# Groundwater Application Review Summary Form

Application # G- 19479

GW Reviewer Gabriela Ferreira Date Review Completed: January 2, 2025

TO: Water Rights Section Date 1/2/2025  
 FROM: Groundwater Section Gabriela Ferreira  
 Reviewer's Name  
 SUBJECT: Application G- 19479 Supersedes review of \_\_\_\_\_  
 Date of Review(s)

**Application G-19479 Colton School D53  
T5S R3E Section 3**

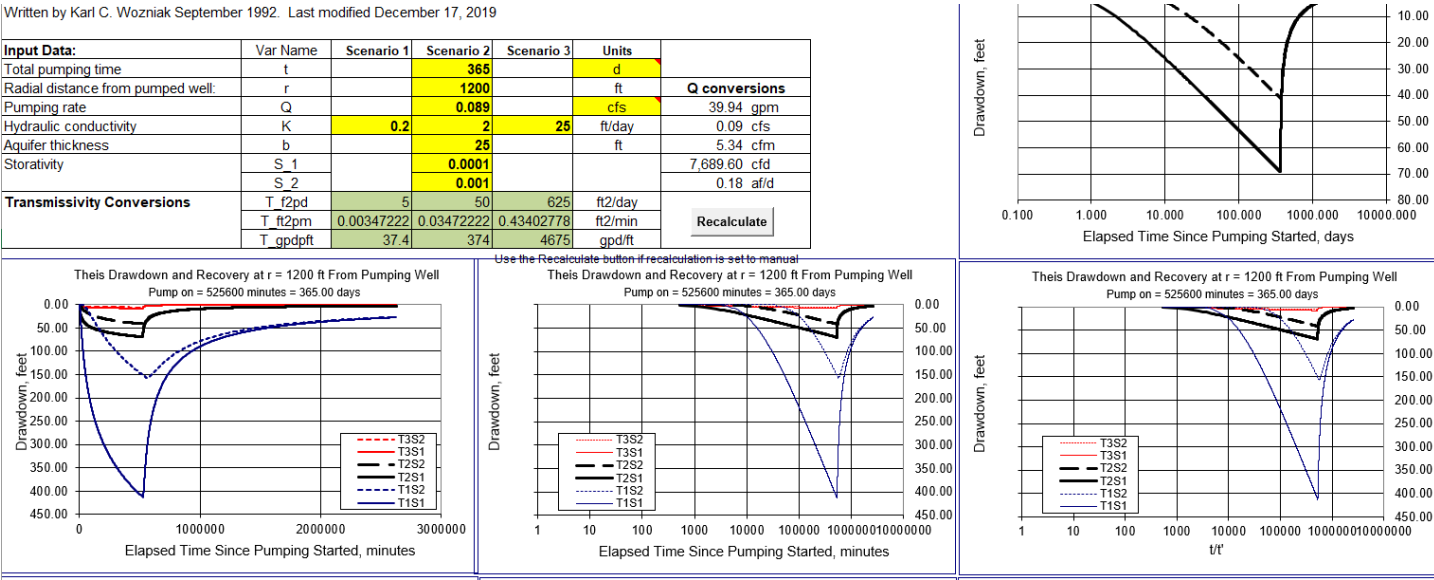
A4. **Comments:** The proposed POAs/POU are located approximately 0.5 miles southeast of Colton and 9 miles southwest of Estacada. The applicant proposes irrigation use on 36.1 acres by two wells to be constructed, for a maximum instantaneous rate of 0.089 cfs (~40 gpm) and maximum annual volume of 43.3 acre-feet.
